Proposed Development and  
Alterations to N52 Inner Relief  
Road at Crowne Plaza Hotel  
Junction, Dundalk

Stage 1 & 2 Road Safety Audit

<b>Document Ref:</b>	<b>P19-011-RP-001</b>
----------------------	-----------------------

Location: Drawing no. SK-30001 (-)

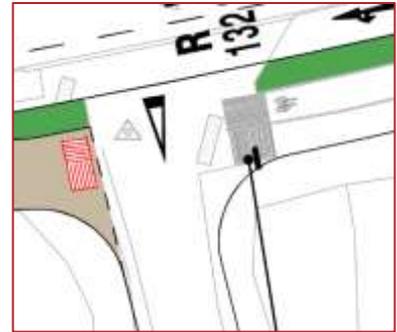
Summary: The proposed tactile paving arrangement across the gated access to the electrical substation may result in visually impaired pedestrians being insufficiently aware that they are crossing a vehicular access and leaving the VRU facilities.

Ladder and tramline tactile paving is indicated on the western side of the vehicular access to the electrical substation at the commencement of the proposed shared surface while there is existing ladder and tramline tactile paving located on the western side of the access.

Visually impaired pedestrians approaching the access may be insufficiently aware that they are entering a carriageway and may perceive the tactile paving to indicate the end of the segregated facilities. This could lead visually impaired pedestrians inadvertently entering the access where there is a risk of being struck by a vehicle.

As the access to the electrical substation is gated and is likely to be lightly trafficked priority at this location should be given to vulnerable road users by providing a continuous shared surface across the access.

The proposed ladder and tramline tactile paving on the western side of the access would therefore not be required. The existing warning tactile at the access could then be removed, while the existing "Ladder & Tramline" tactile markings should be retained to define the transition from the shared to the segregated surfaces.

Location: Drawing no. SK-30001 (-)

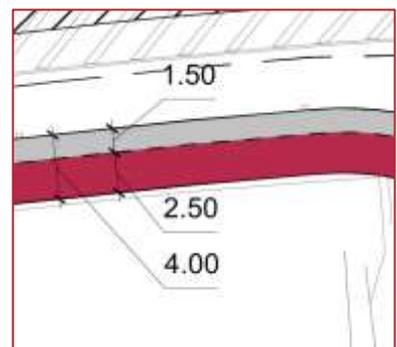
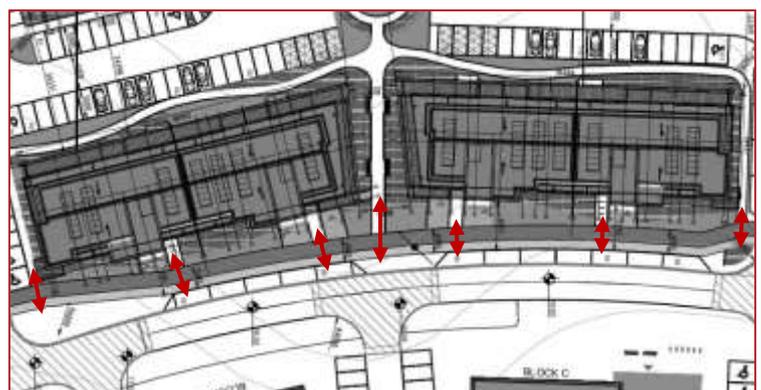
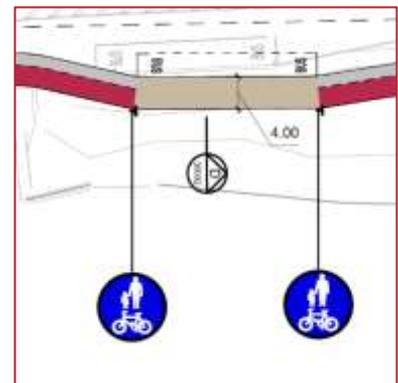
Summary: The cycletrack has been indicated on the inside of the footpath which is not consistent with the National Cycle Manual preferred arrangement or the existing facilities to the east of the Crowne Plaza Hotel junction.

A segregated footpath and cycletrack has been indicated from the proposed development onto the R215 with the cycletrack indicated on the inside of the footpath which is shown adjacent to the carriageway.

The National Cycle Manual, for all types of segregated cycle facility, shows the cycletrack adjacent to the carriageway. There is an existing segregated facility on the southern side of the R215 to the east of the electrical substation access which has the cycletrack adjacent to the carriageway and the footpath on the inside.

The proposed arrangement extends into the development, where the provision of the footpath adjacent to the carriageway facilitates passenger egress from vehicles parked at the kerb. However, the arrangement shown requires all pedestrians entering/exiting the buildings within the development to cross the cycle track to reach the footpath.

It is likely that cyclists and pedestrians already travelling on the existing westbound facilities east of the Crowne Plaza Hotel junction will then continue travelling within the incorrect path/track downstream of the crossing resulting in the potential for pedestrian-cyclist collisions.

Provide a shared surface instead of separate cycle & pedestrian facilities, which would also remove the need for tactile surfaces at the interfaces with the other shared surfaces along the R215.

Alternatively, amend the segregated pedestrian and cyclist facilities so that the footpath is on the inside and the cycletrack is adjacent the carriageway. The footpath level should be above the level of the cycletrack.

*Location:* Drawing no. SK-30001 (-)

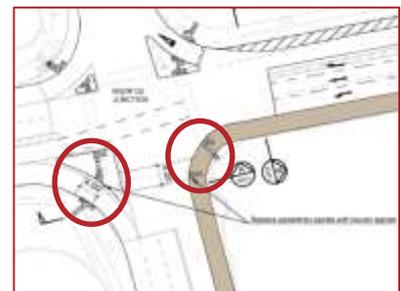
*Summary:* Ladder and tramline tactile paving has not been indicated either side of the proposed shared surface at the westbound bus layby or at the transition to the shared surface on the westbound approach to the R132 junction.

The segregated footpath and cycletrack transitions to a shared surface at the bus layby on the westbound carriageway of the R215 and on the approach to the R132 junction.

Ladder and tramline tactile paving has not been indicated at the start and end of this section of shared surface. This could lead to visually impaired pedestrians approaching the shared surface in the footpath being insufficiently aware that they are entering a shared area where cyclists may also be present which could result in an increased risk of pedestrian-cyclist collisions.

Provide ladder and tramline tactile paving at the interfaces between shared and segregated surfaces.

Alternatively, as recommended in Problem 3.1.4, a shared surface could be provided throughout the Scheme in lieu of the proposed segregated pedestrian & cyclist facilities.

*Location:* Drawing no. SK-30001 (-)

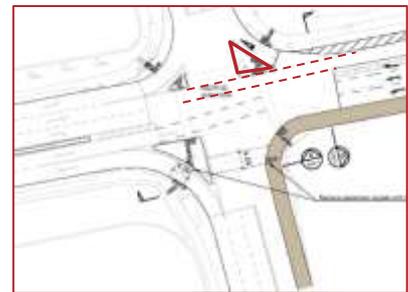
*Summary:* Existing tactile paving provision, as indicated on the drawing, may not be appropriate for the proposed toucan crossings.

It is proposed to replace the existing, although possibly unused, pedestrian crossing of the R132, south of the R215 junction, and the associated segregated left turn slip with toucan crossings to facilitate both pedestrians and cyclists.

The existing tactile paving arrangement is indicated as being retained at these crossings, including one provision where chamber covers encroach into the tactile paving layout.

This existing tactile paving arrangement may not be appropriate for the proposed Toucan crossings, which are 4m wide, as the existing tactile paving will not extend across the full width of the proposed crossing. This could lead to visually impaired pedestrians inadvertently entering the carriageway where the tactile paving does not extend over the full width of the dropped kerb with a resulting increased risk of being struck by a vehicle.

The existing tactile paving arrangements should be replaced or amended with new tactile paving suitable for the proposed toucan crossing.

It may also be necessary to change the existing pedestrian crossings of the R215 to the west of the junction to toucan crossings, or to provide 'box turn' arrangements, to facilitate cyclists wishing to travel northbound from the R215 westbound approach.

*Location: Drawing no. SK-30001 (-)*

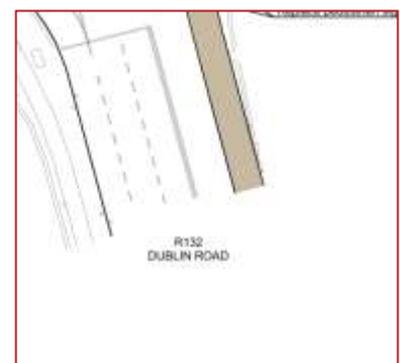
*Summary: Risk of eastbound drivers entering the incorrect lane downstream of the junction as lane guidance markings have not been provided for this movement.*

The inclusion of an additional third lane on the westbound carriageway of the R215 results in the through traffic lanes being offset from the downstream lane on the other side of the junction. Lane guidance markings have been indicated for westbound drivers travelling straight-ahead at the R132/R215 junction, however no guidance markings have been indicated for eastbound straight-ahead traffic. This could lead to eastbound drivers potentially entering the opposing right turn lane where there is a risk of head-on collisions with vehicles waiting in this lane.

In addition, large eastbound vehicles may strike the existing splitter island in the north-eastern quadrant of the junction as they enter the downstream eastbound lane resulting in material damage collisions.

Provide lane guidance markings at the R132/R215 junction for the eastbound through movement. The north-eastern splitter island may also require amendment to ensure all vehicles can safely undertake the through movement within the carriageway extents.

*Location: Drawing no. SK-30001 (-)*

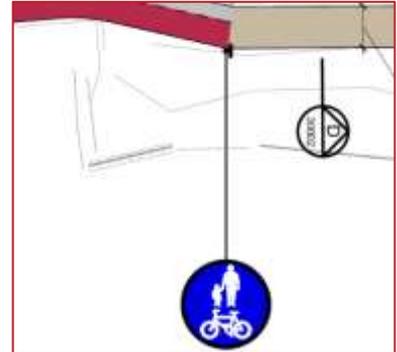
*Summary: Proposed shared surface on the R132 does not tie-in with similar facilities.*

A shared surface of width 3.0m is proposed on the southern side of the R215 carriageway, which extends onto the R132, terminating south of the R132/R215 junction. This proposed facility does not tie-in with an existing facility at this location and the existing footpath at this location is not wide enough to accommodate both pedestrians and cyclists. Should vulnerable road users be directed onto this existing footpath there is a risk of collisions between pedestrians and cyclists.

1. Advance stacking locations (ASLs) have been indicated on the approaches to the Crowne Plaza Hotel junction. Section 4.4.1 (point no. 6) of the National Cycle Manual states that “ASLs must always be “fed” by a cycle lane to ensure that cyclists can pass stationary traffic and get to them.” No on-road cycle facilities are proposed on the approaches to the ASLs, and it may be preferable to omit them from the design.
2. The shared surface sign indicated at the western side of the shared surface at the bus layby on the westbound carriageway of the R215 is indicated as facing in the incorrect direction. This should be amended to face towards pedestrians and cyclists approaching from the west.

The arrangement at the tie-in of the proposed shared surface and the existing footpath on the R132 should be amended so that southbound cyclists are safely transitioned onto the southbound R132 carriageway to continue their journey.

3.1.1	Y	Y		
3.1.2	Y	Y		
3.1.3	Y	Y		
3.1.4	Y	Y		
3.1.5	Y	Y		
3.1.6	Y	Y		
3.1.7	Y	Y		
3.1.8	Y	N	Louth County Council has a programme of works to enhance the cycling network in Dundalk. Any interventions here would be premature in advance of same. There is a simple transition onto road for cyclists at the dropped kerb at the access immediately south of the proposed pedestrian crossing.	Yes

*Location:* Drawing no. 1611-PA-003

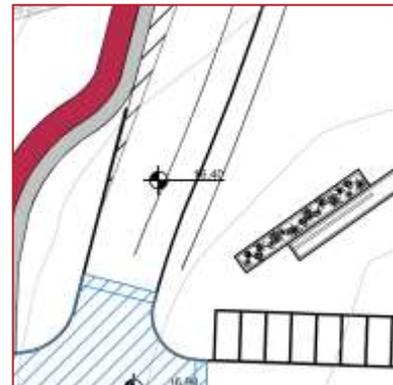
*Summary:* The pedestrian routes through the proposed development are unclear, including where crossings are proposed, the arrangement of the VRU facilities (shared or segregated) and the lack of tactile paving at proposed crossing points.

The footpath on the western side of the access road to the proposed development appears to terminate south of the Crowne Plaza Hotel junction without connecting to other pedestrian routes.

Apart from the primary footpath/cycletrack through the spine of the development, the footpath arrangements within the development, outside the public open space and cluster of apartment blocks, is unclear.

Crossing locations are not clearly indicated and where crossings appear to have been provided these do not line up with an opposing footpath, while some terminate at car parking spaces.

A failure to provide suitable access points to the footpaths could lead to mobility impaired pedestrians, who cannot mount a full-height kerb, becoming stranded within the carriageway or having to travel within the carriageway to the nearest dropped kerb location resulting in an increased risk of being struck by a vehicle.

Tactile paving is also not indicated within the development which increases the difficulty in determining where proposed crossing points are located. If tactile paving is not provided at crossing points this could lead to visually impaired pedestrians inadvertently entering the carriageway where they are at risk of being struck by a vehicle.

Ensure the pedestrian routes within the proposed development are continuous, clearly defined and include dropped kerbs and tactile paving at all crossing points.

Location: Drawing no. 1611-PA-003

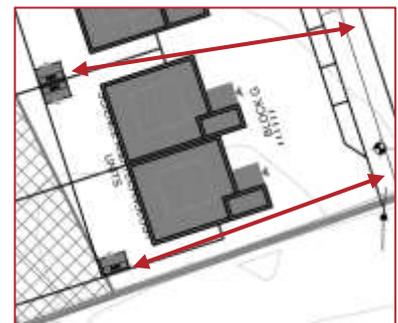
Summary: *Turning heads have not been indicated at the end of cul de sacs within the proposed development.*

Cul de sacs have been indicated throughout the proposed developments. Turning heads have not been indicated at the end of cul de sacs in all instances.

A failure to provide a turning head at these locations could result in large vehicles being unable to undertake a u-turn manoeuvre within the carriageway resulting in them undertaking unsafe reversing manoeuvres where there is a risk of collisions with other road users.

1. It is unclear if the link from the western boundary of the proposed development to the R132 is a shared area for all vulnerable road users or just cyclists. The shared area for motorised and non-motorised road users within the development, if this is what is intended, should be highlighted through the provision of alternative surface materials rather than a cycle symbol to avoid confusion. Also, if the link to the R132 is not intended for motorised vehicles measures should be provided at each end to deter drivers from entering the facility.

2. Bin stores have been indicated adjacent the buildings within the proposed development. Some of the bin-stores are indicated away from the carriageway (e.g. for Science & Technology Units Block G & H or to the rear of parking spaces (Block B)).

Bins could be left in inappropriate locations for collection which could lead to refuse trucks stopping at unsafe locations in order to collect them. Bins left within footpaths or cycle tracks could present a hazard to these road users.

Turning heads should be provided at the end of cul de sacs.

The ends of some cul de sacs have been indicated as being designated for future access to the proposed development. Nevertheless, in the interim, turning heads should also be provided at these locations.

Designated locations should be identified throughout the development, close to the carriageway, where bins can be easily transported to for safe collection.

3.2.1	Y	N	A shared surface approach has been revised into the design to avoid confusion in this location.	Yes
3.2.2	Y	Y		
3.2.3	Y	N	These roads have been extended from the parking bays to the property boundary at the direction of the Local Authority. They will only be used for car parking and, as such, the provision of turning heads is considered to be unnecessary.	Yes
